BOARD MEETING

AGENDA

WEDNESDAY, SEPTEMBER 2, 2026

Bucks County Planning Commission

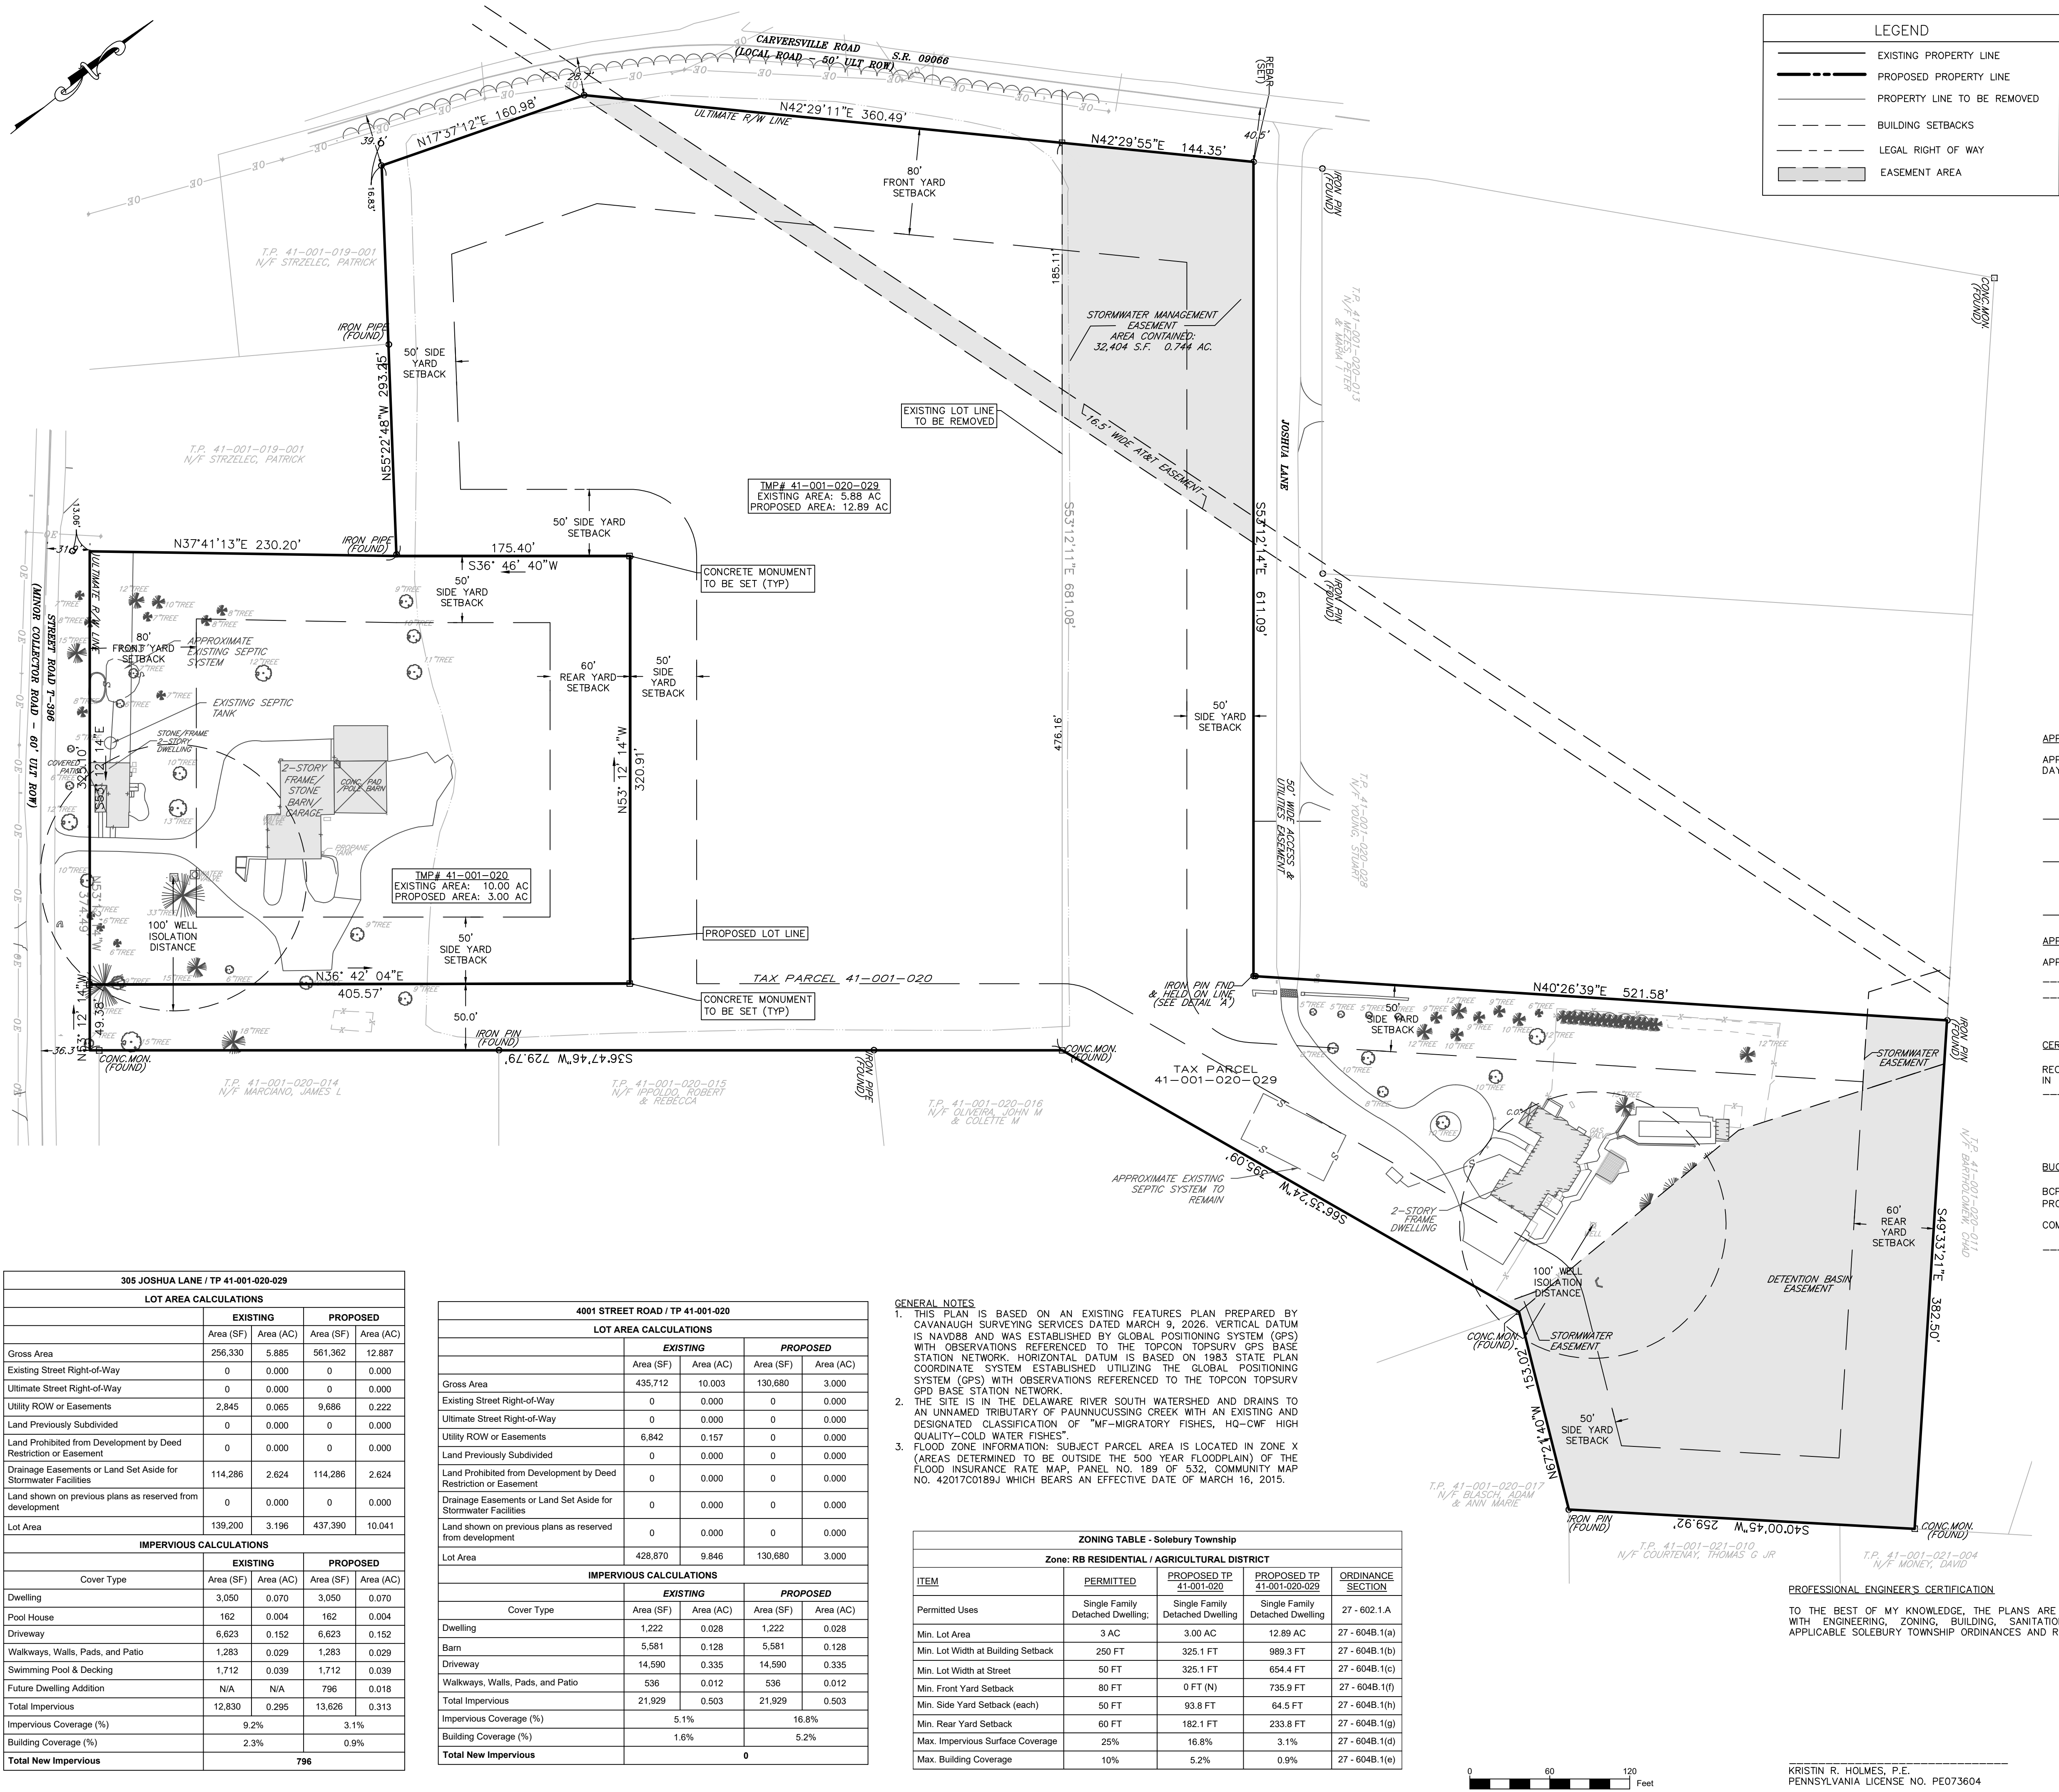
2. **Site capacity calculations**—Section 27-511.1. of the zoning ordinance requires site capacity calculations to be submitted with all applications for subdivision or land development. The land development plan does not include the required site capacity calculations.

3. **Encroachment on adjacent property**—The proposed access scheme will encroach on the adjacent property. We recommend that the encroachment be eliminated or consideration be given to obtaining a permanent access easement.
